STAFF DEVELOPMENT REVIEW COMMITTEE MEETING MINUTES

MEETING DATE: June 11, 2019

PCD REZONING/
THE PALMS AT ASHTON LAKES PCD
CASE NO. 19-65000001
OUTSTANDING TECHNICAL COMMENTS AS OF JUNE 7, 2019

SITE PLAN/NEW PORT APARTMENTS

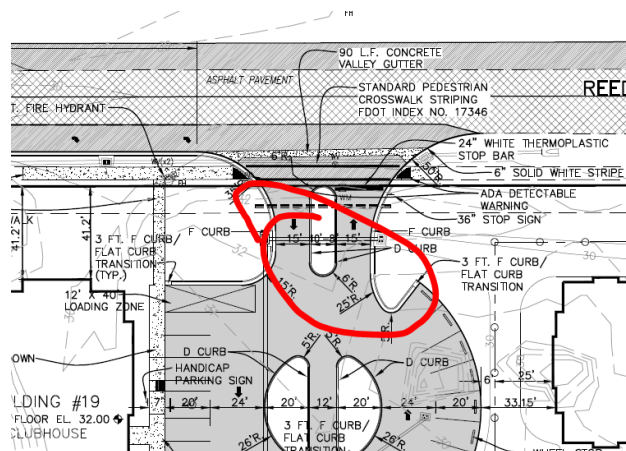
1. Provide a detail for the proposed Knox Box with the next submittal for the Fire Department and emergency services to grant minimum access in case of an emergency. **Suggestion**: Knox Box padlock (<http://www.knoxbox.com/store/Knox-Padlocks.cfm>).
2. On Sht. 8 of the Site plan, revise the entrance and exit drives from Reed Canal to be 20' instead of 15'. NFPA 1, Ch. 18 (Fire Department Access) states the following:
